RE: Meggison Road Phase Seven Multimodal Crossing –Citizen Concerns

The Sumter County Board of County Commissioners (BOCC), received multiple concerns from residents regarding the Meggison Road Phase Seven multimodal crossing at station 136+25. Sumter County staff have reviewed the concerns, with the Engineer of Record (EOR), and provide the following responses and recommendation for Sumter County BOCC consideration.

To: Mr. Bradley Arnold – Sumter County Administrator
From: Amber L. Gartner, PE; Kimley-Horn and Associates, Inc.
Date: March 30, 2020
RE: **Meggison Road Phase 7**
Kimley-Horn Project Number 042212107

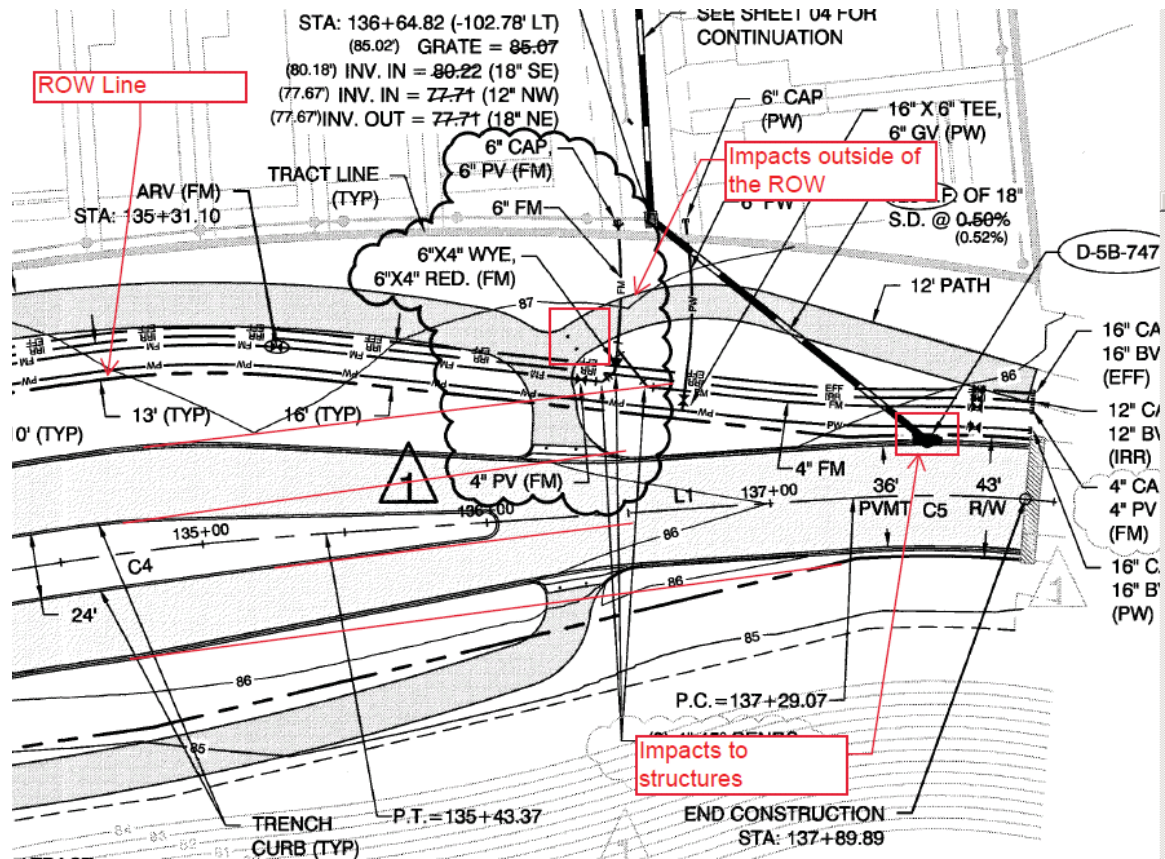
- *Widen and lengthen the median to provide a refuge area for a two-stage maneuvers*
 - Sumter County does not have sufficient ROW to extend the median and still provide sufficient taper lengths for the mainline to the southeast. An extension of the median would directly impact the facilities outside of Sumter County's ROW including drainage structures, pedestrian paths, bollards, etc. County staff does not recommend this revision. Please see the attached diagram of what facilities would be impacted.
